| Xcel Energy | | Information Request No. | 6 |
| Docket No.: | E002/M-19-666 | | |
| Response To: | Fresh Energy | | |

Geo-targeted Distributed Clean Energy Initiative

Figure [FE-9] 1: Illustration – EV Impact in Relation to Historical Residential Loads

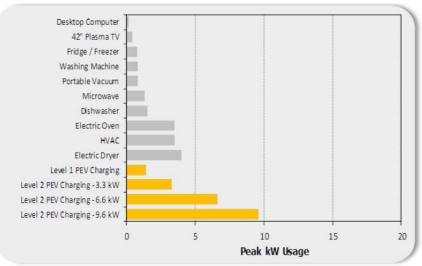
Please provide all data, analysis, studies, reports, or spreadsheets with all formulas and links intact supporting the Company's claim that its system is in need of investment to "prepare ... for electric vehicle penetration in advance of rapid and widespread customer adoption."

The figure below illustrates the large impact EV charging could play on a neighborhood secondary system compared to historical loads.

Minnesota CMO 2014 - 2018 All Days

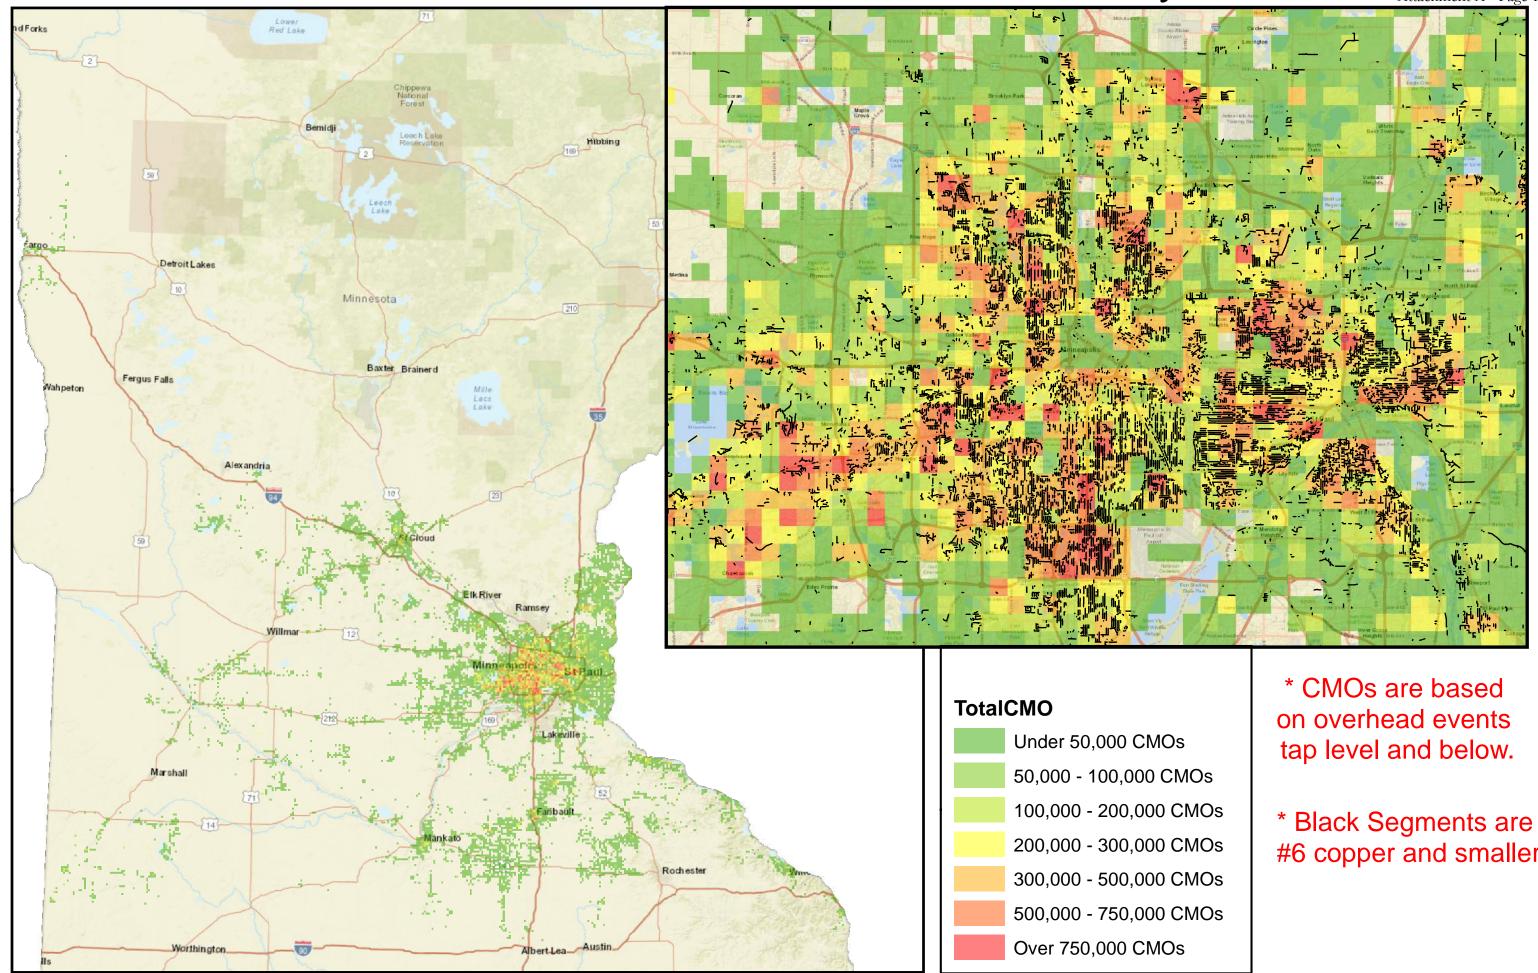
- A. Underground 20 miles of overhead tap system in 2021 and 30 miles in 2022.
- B. Reinforce the equipment on up to 900 poles in 2021 and 2022.
- C. Replace the transformer and the associated secondary wire at up to 150 locations in 2021 and 2022.
- D. Address up to 200 different high customer count taps in both 2021 and 2022.

We provide Attachment A, which is an example of work we have underway that will assist in identifying areas of opportunity for overhead tap programs. It is a map of our Minnesota service area color-coded based on volume of customer minutes out (CMO) for the 2014-2018 time period, and the location of smaller conductor that may not adequately support changing customer service demands, including those stemming from EVs and DER.
